Request for Class II Permissive Change

FCC ID: RSFXM925AYY

Please be notified that we, the undersigned, **Guangdong Midea Kitchen Appliances Manufacturing Co.,Ltd**. declare that the reasons for this class II permissive change are as below:

New Mother board –top view

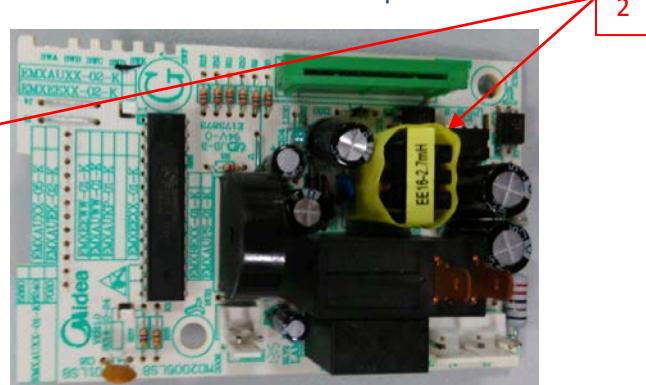
1. Changed Mother -board as below.

NOTE: 1: They have the same input&output power and similar circuit function.
2: Changed linear transformer to switch power supply.
